SERVICE BULLETIN

KWM-2/KWM-2A TRANSCEIVERS SERVICE BULLETIN NO 3 (REISSUE)

EQUIPMENT: KWM-2 Transceiver (522-1611-000)
KWM-2A Transceiver (522-1792-000)

SUBJECT: Correlation Between Frequencies on Different Bands

KWM-2 After Modification, Schematic Change

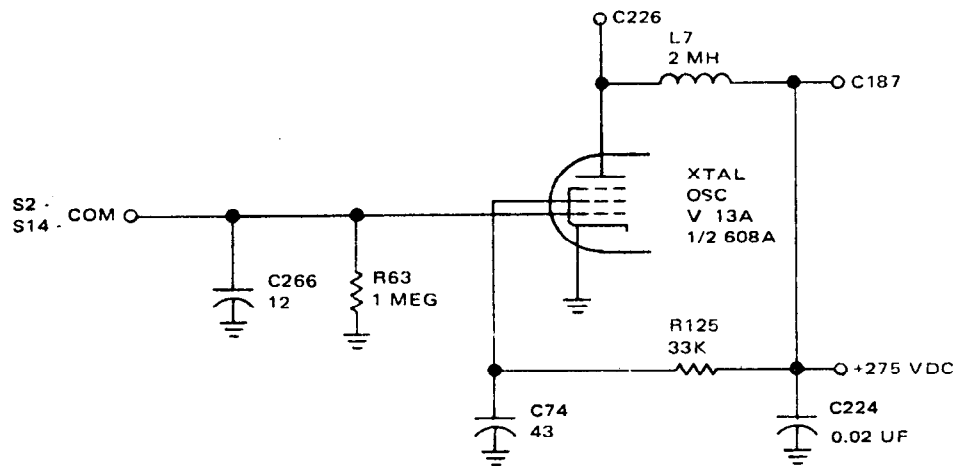
- c. Remove and discard 27-pF capacitor C266, if present, from XV13A pin 2 to the center shield of V13 (ground), and install at this location a 12.0-pF capacitor (912-2757-000), KWM-2 only.
- d. Remove and discard 47-k Ω resistor R125 from XV13A pin 2 to vector terminal board E100, and replace with 33-k Ω resistor (745-1415-000).
- e. Remove and discard 47-pF capacitor C74 from XV13A pin 3 to ground, and replace with 43.0-pF capacitor (912-2789-000).
- f. Inspect unit for damage incurred during modification, dress wires and cables, and remove debris.
- g. Reassemble unit by reversing step a.
- h. Check transceiver for proper operation.
- i. Mark information chart (280-3778-010) SB 3R. Apply chart to convenient location on unit if one is not present.

NOTE:
C266 NOT USED IN KWM-2A.
